**DECLARATION FOR THE
SECOND EXPLANATION OF SIGNIFICANT DIFFERENCES
ELIZABETH MINE SUPERFUND SITE
STRAFFORD/THETFORD, VERMONT
2015**

DRAFT FOR PUBLIC COMMENT

**SECOND EXPLANATION OF SIGNIFICANT DIFFERENCES
ELIZABETH MINE SUPERFUND SITE
STRAFFORD/THETFORD, VERMONT
2015**

Phase 2 RA Explanation of Significant Differences
Elizabeth Mine Superfund Site
South Strafford, Vermont

Figure 3

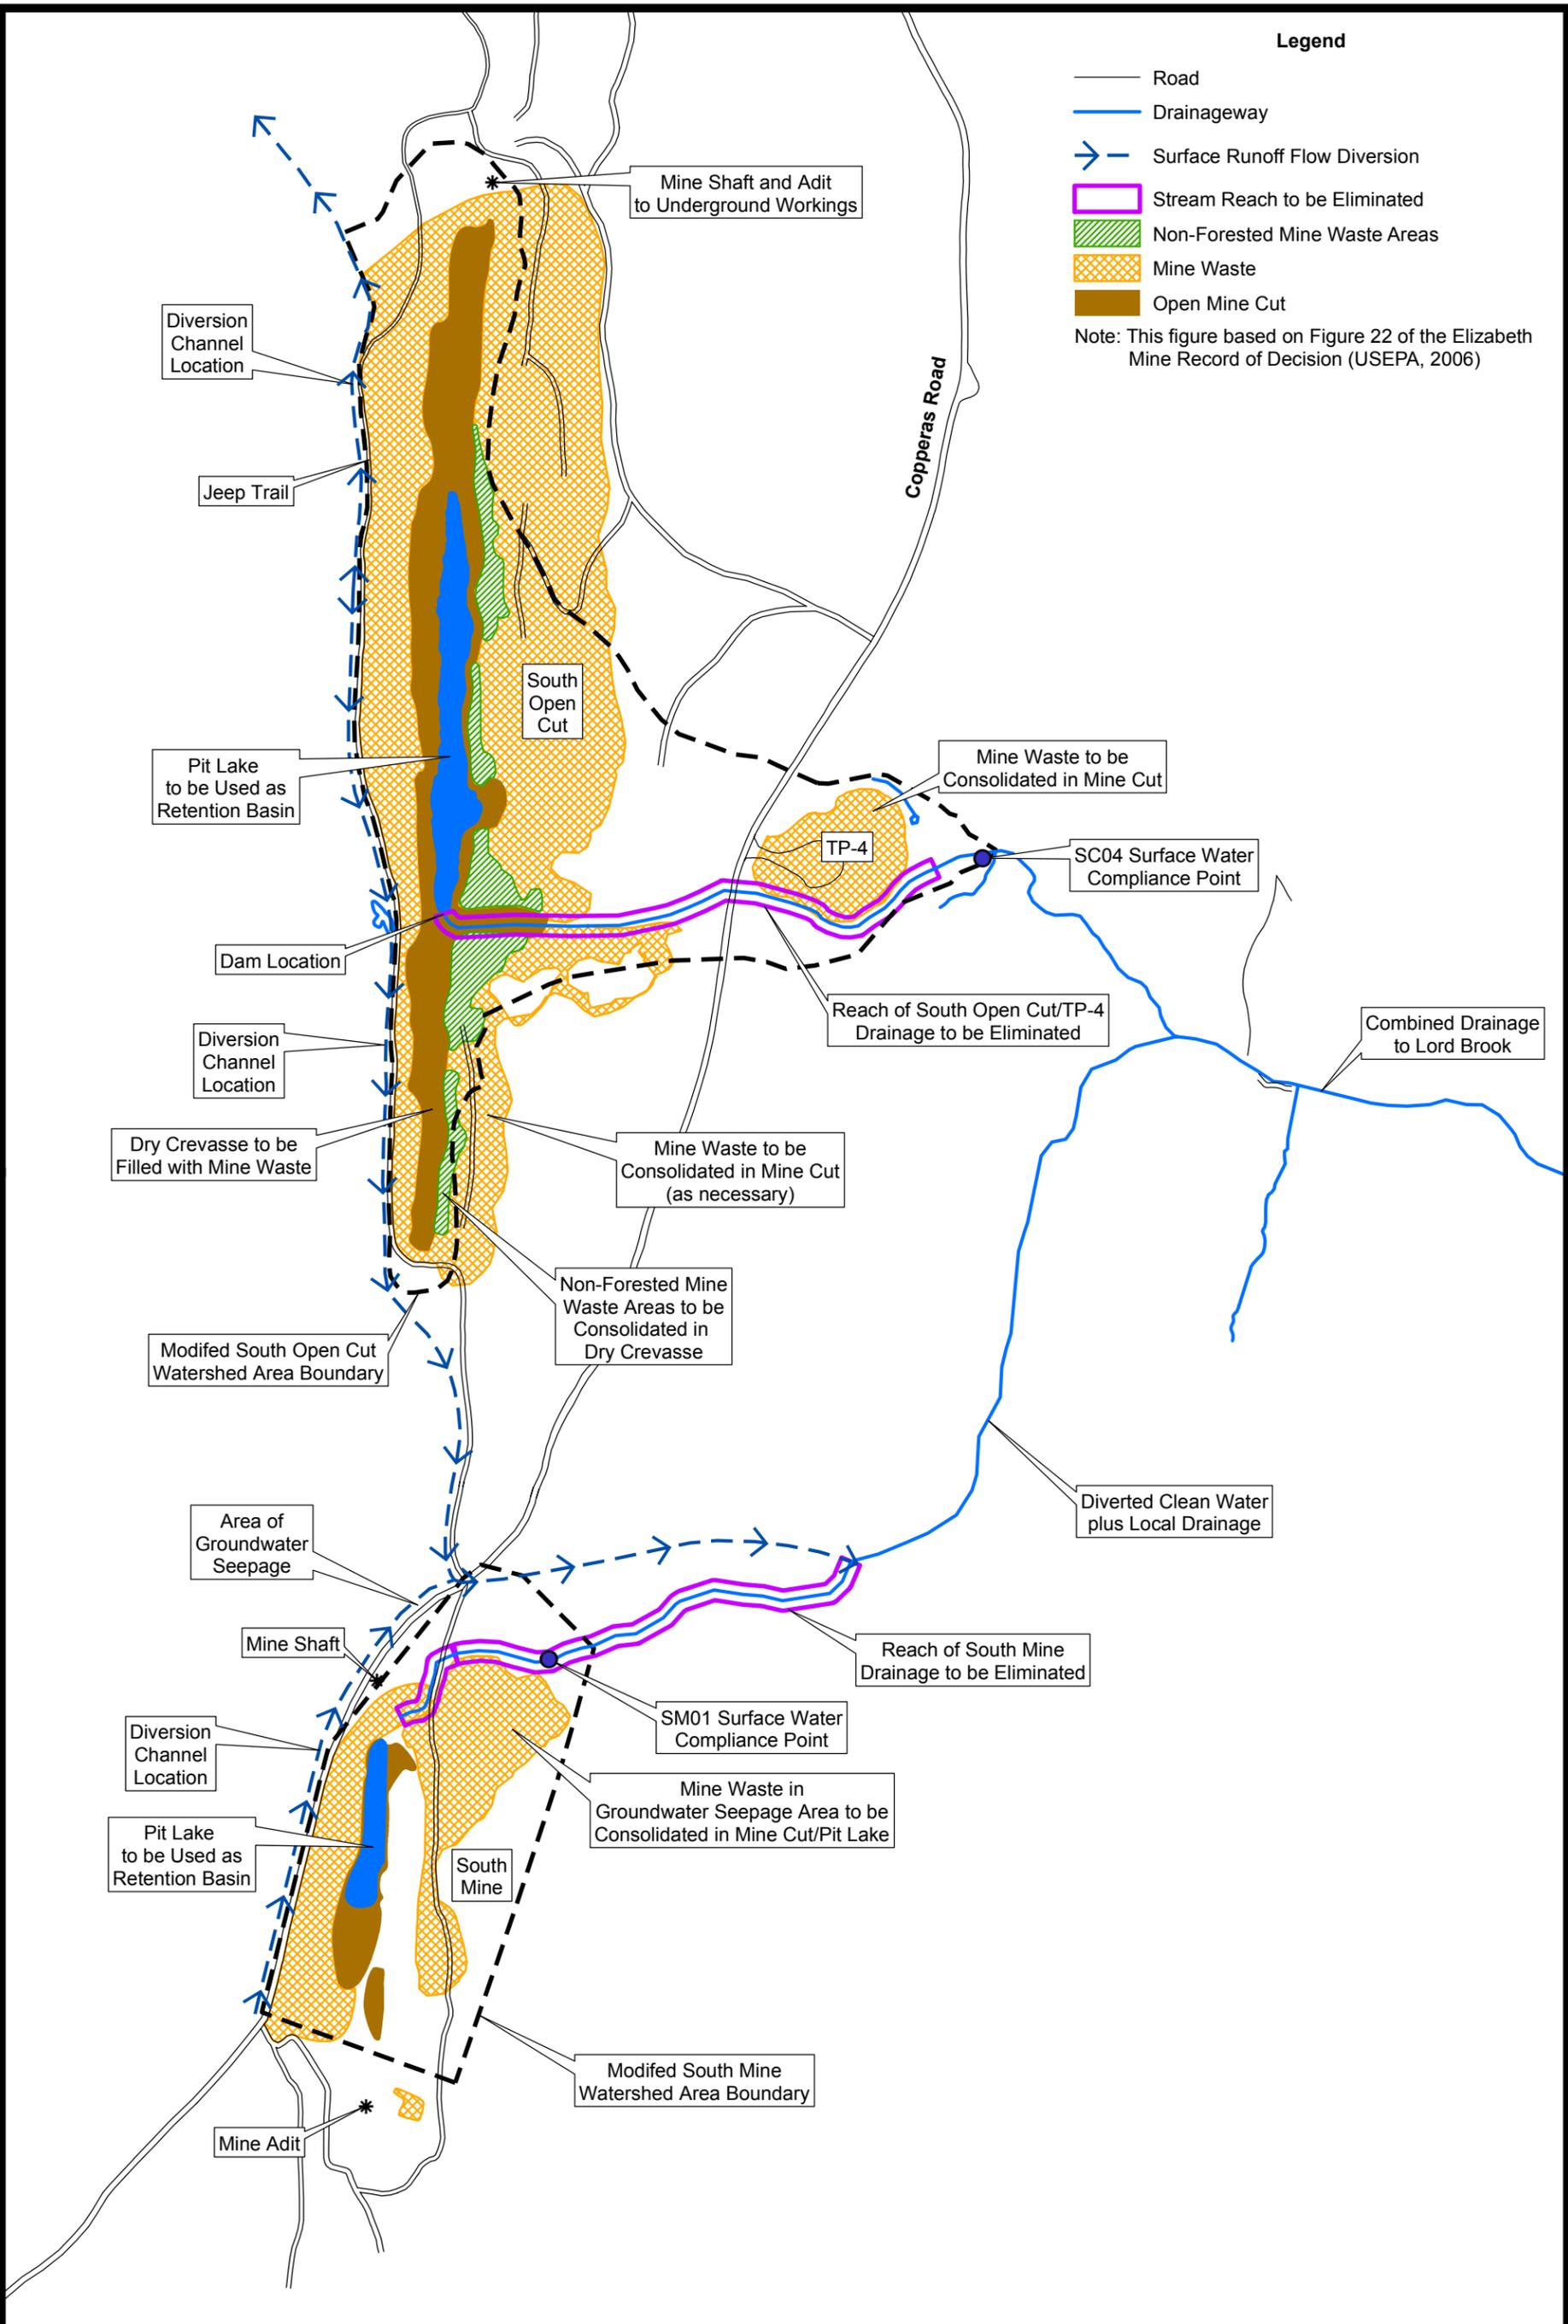
The 2006 ROD description of the Phase 2 selected remedy is provided below and shown in Figure 3.

Figure 4

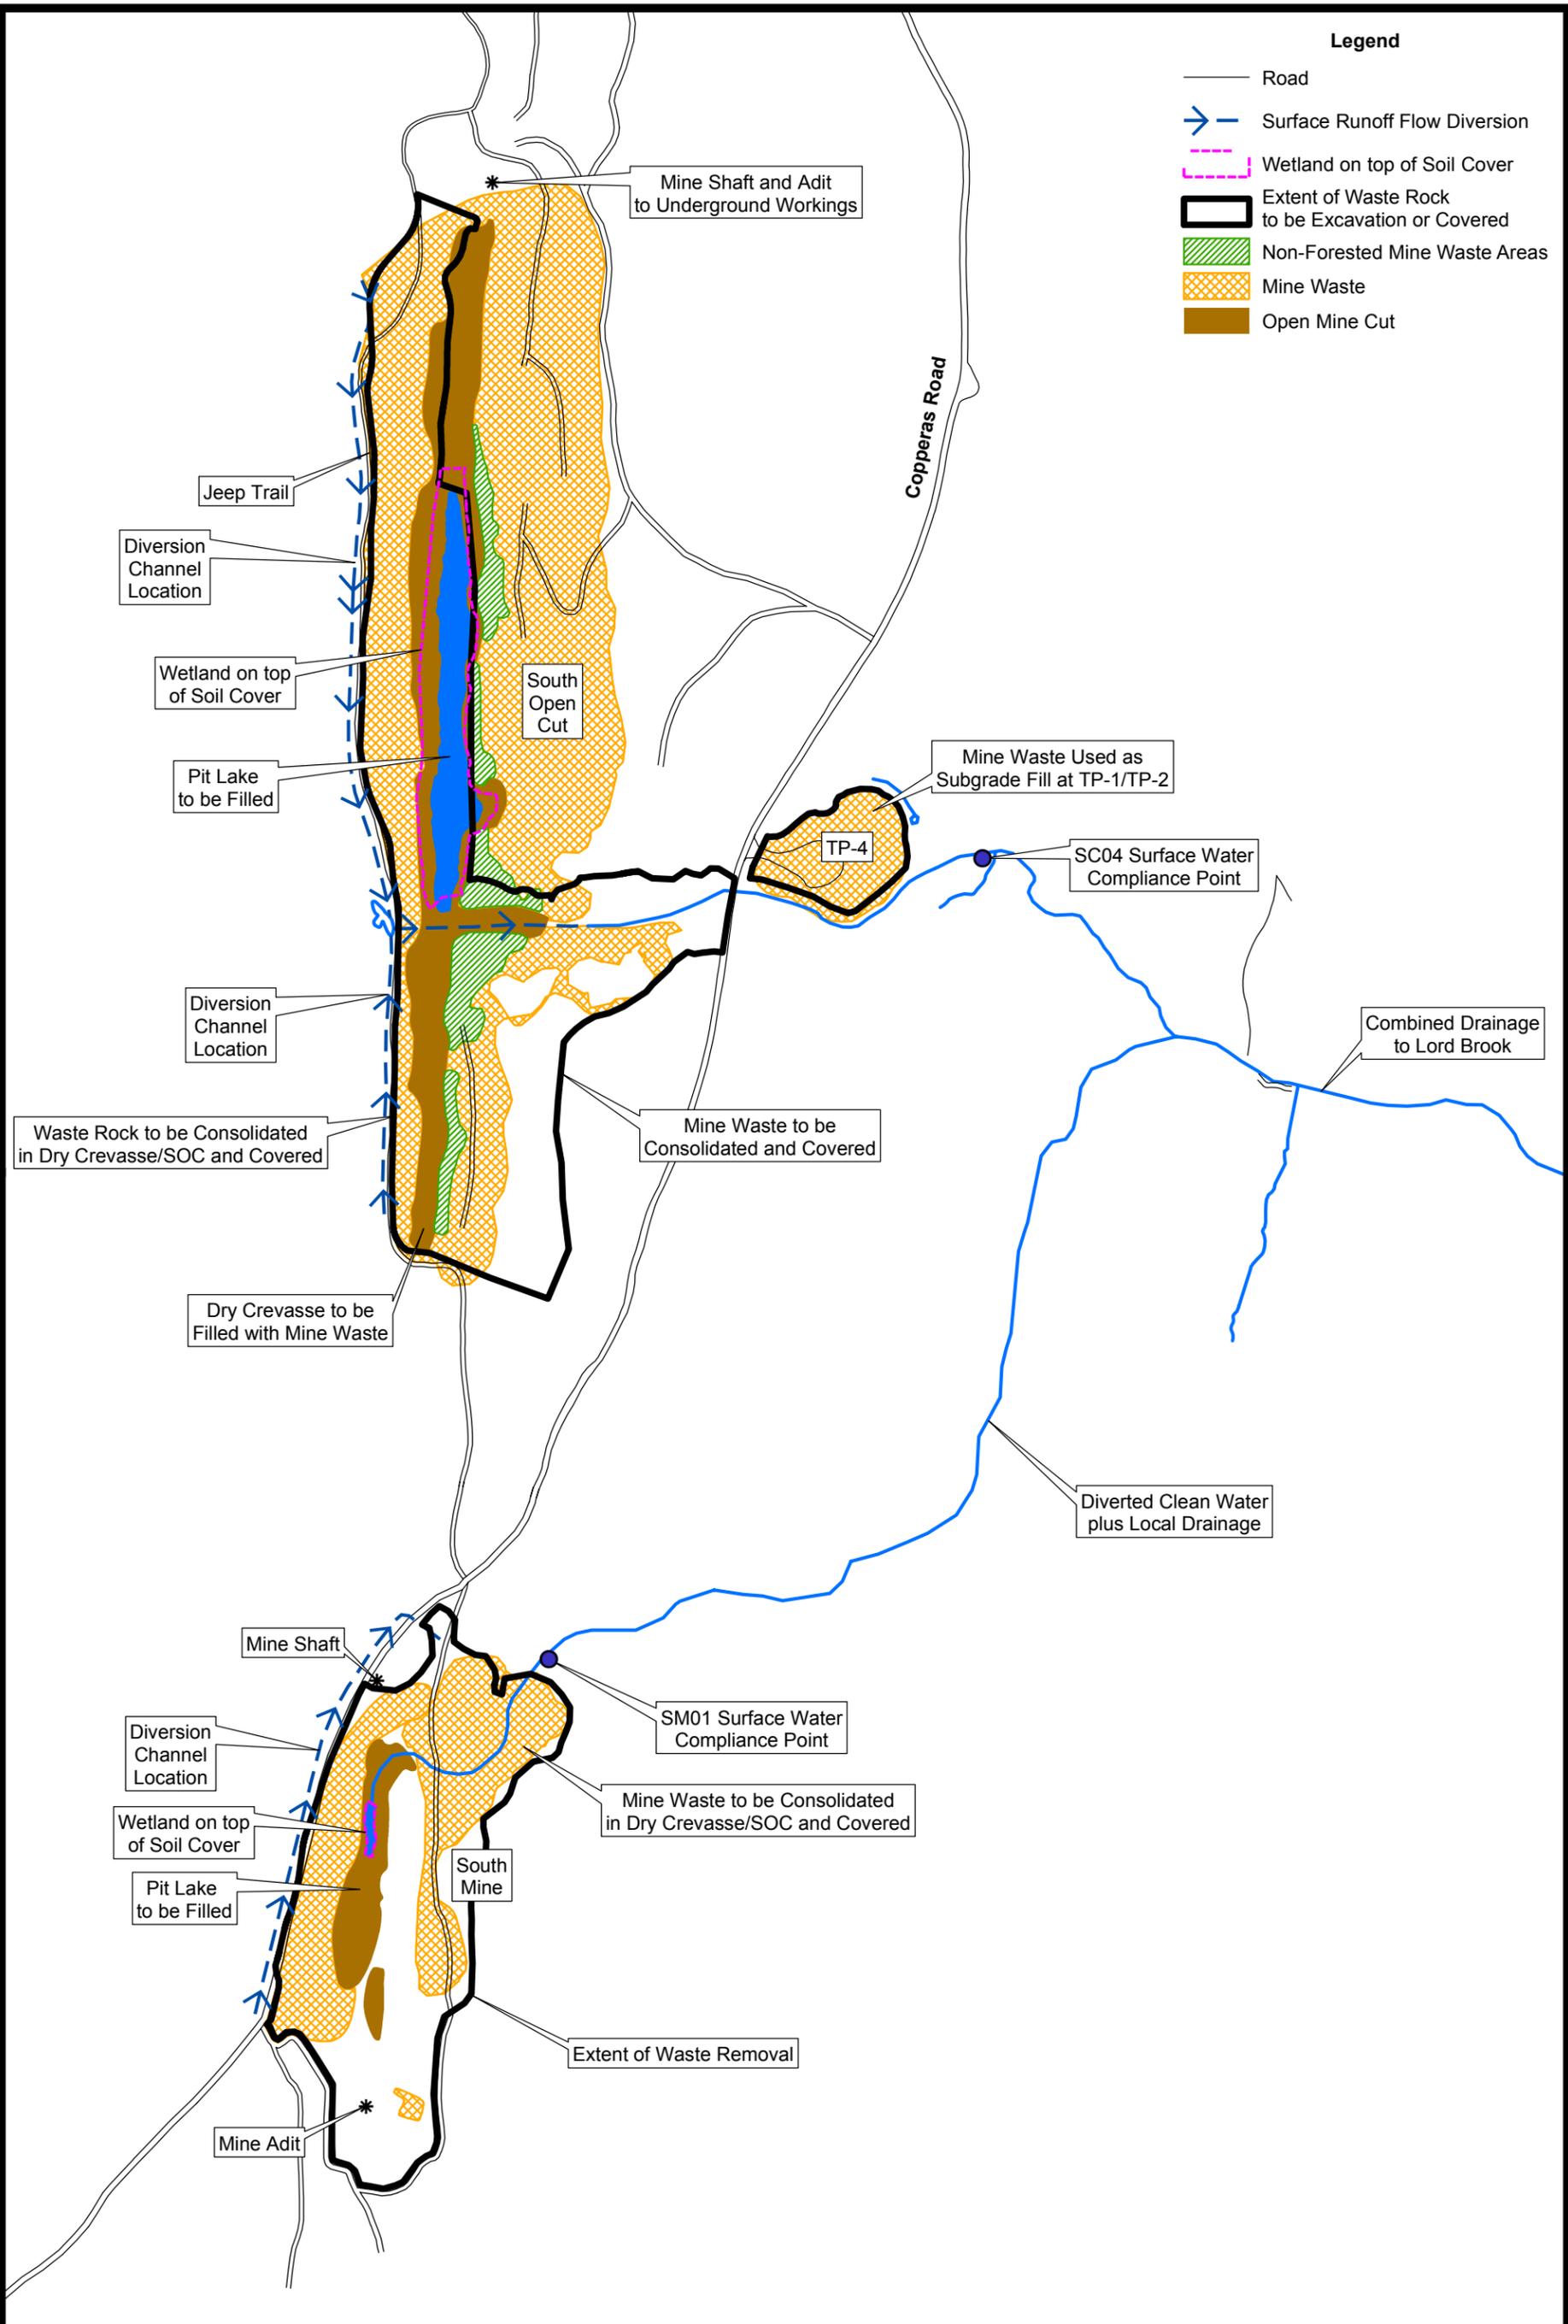
Under this ESD's modified remedy the acid mine drainage discharge from the South Mine and South Open Cut pit lakes will be eliminated by filling the pit lakes with waste rock and installation of a soil cover. Under this ESD's modified remedy treatment of the South Mine and South Open Cut pit lake water will occur as a result of the permanent dewatering of these features to implement the cleanup (requiring a greater volume of water to be treated than under the ROD remedy). Under this ESD, the possible options for where treated water may be discharged during remedy implementation has been expanded to include into Copperas Brook and/or the underground workings, as well as into the tributaries to Lord Brook. The ROD only identified the Lord Brook tributaries as discharge points for treated water from the remediation. Figure 3 shows the cleanup based on the 2006 ROD and Figure 4 shows the revised Phase 2 cleanup based on the final design and this 2015 ESD. The points of compliance for the Phase 2 cleanup are shown in Figure 5 and are designated SC4 (South Open Cut point of compliance) and SM1 (South Mine point of compliance).

Pre-remediation Wetlands and Aquatic Resources at Lord Brook Source Areas
Figure 6

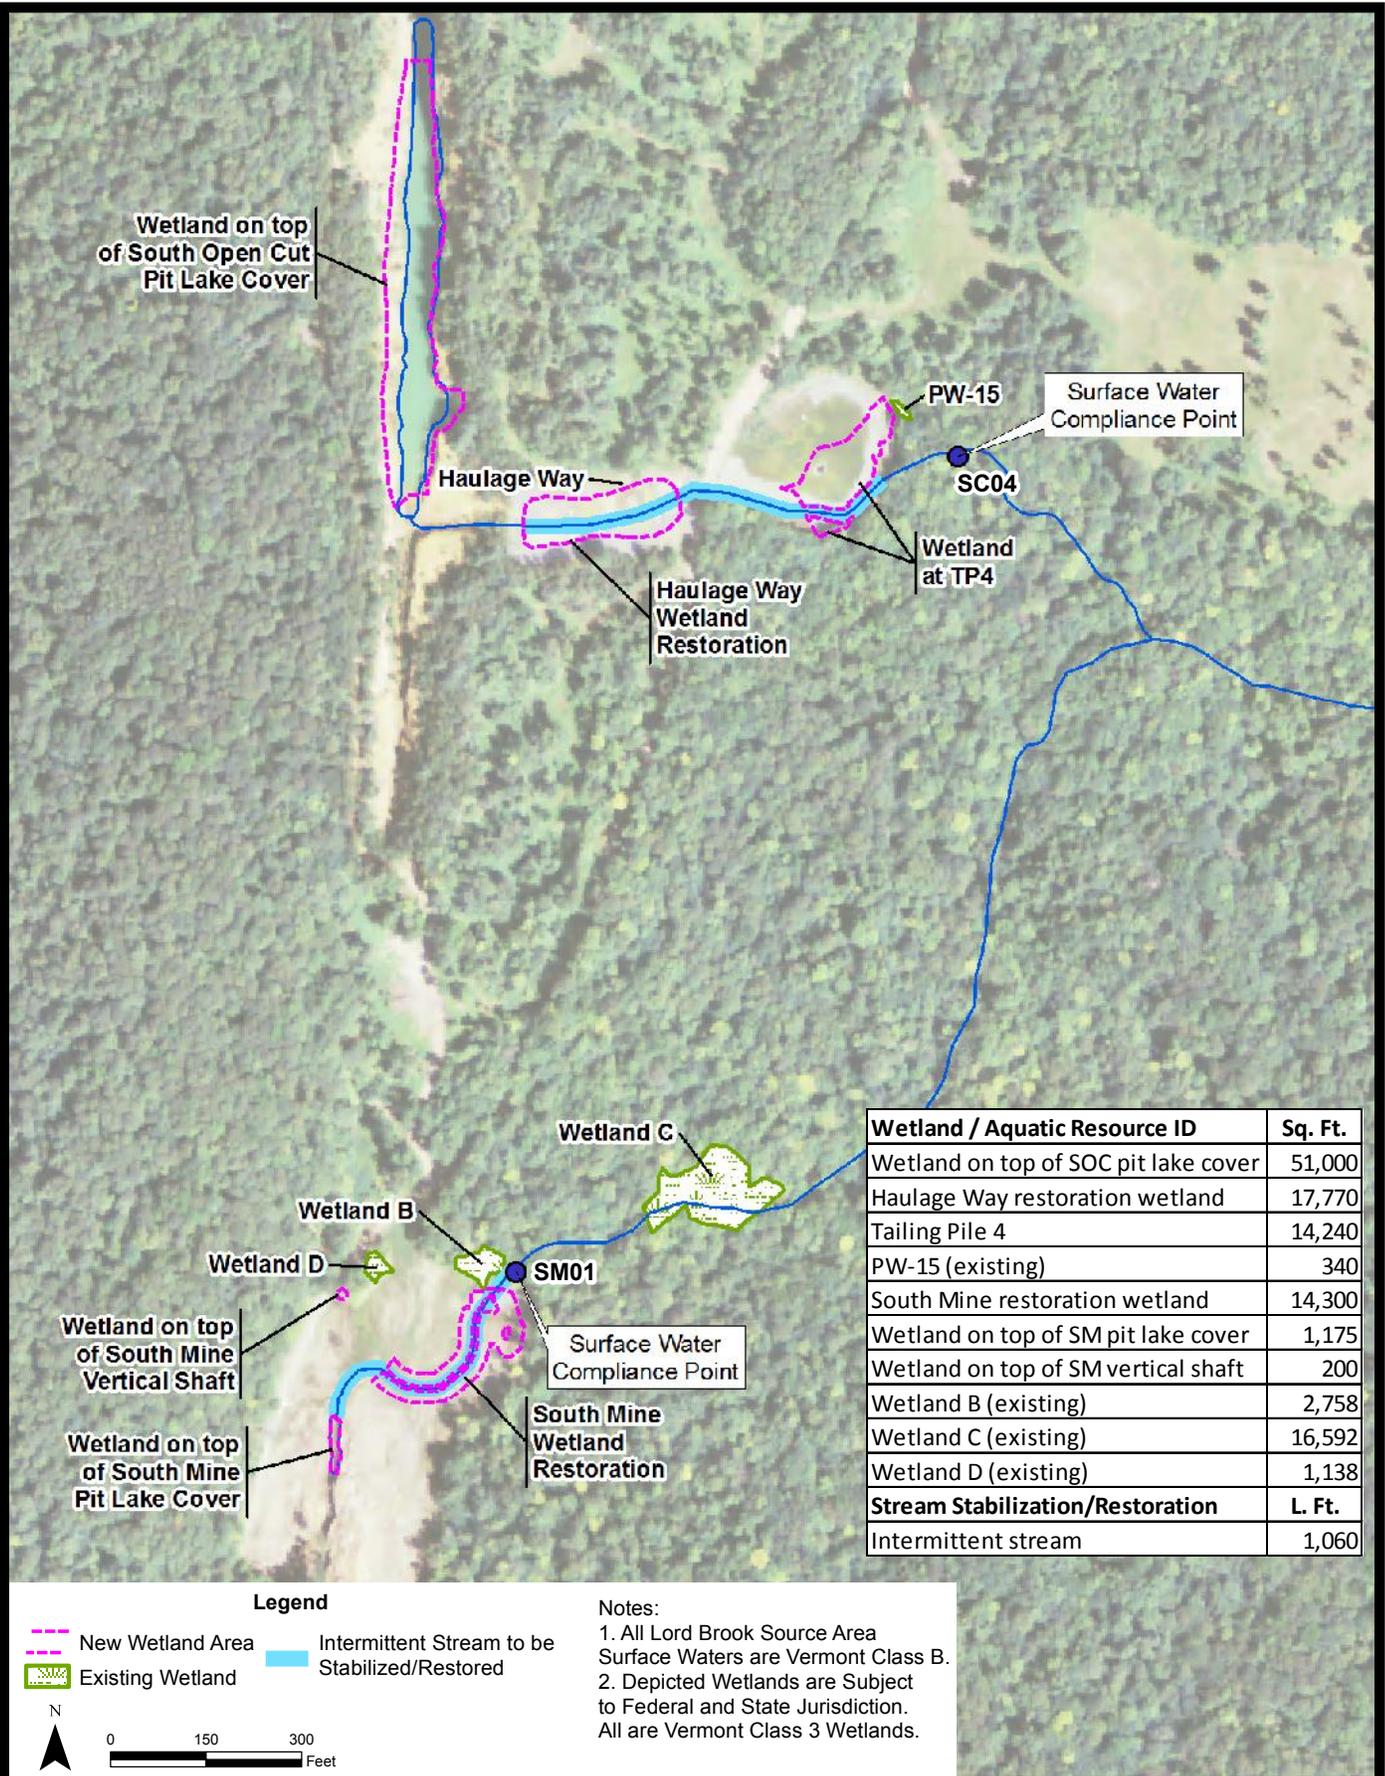
EPA has re-evaluated the requirements of the applicable federal Clean Water Act standards and determined that the revised cleanup approach remains the least environmentally damaging practicable alternative to protect downstream federally regulated wetland and aquatic resources from acid rock drainage. No federal jurisdictional wetlands are present within the area to be altered by the revised remedy, although State jurisdictional Class 3 wetlands will be altered. Mitigation measures, as practicable, to compensate for the alteration of the Class 3 wetlands will be incorporated into the design of the revised remedy. Figure 6 shows the delineated wetlands within the Phase 2 RA area and Figure 7 shows the wetlands after the Phase 2 Remedial Action.
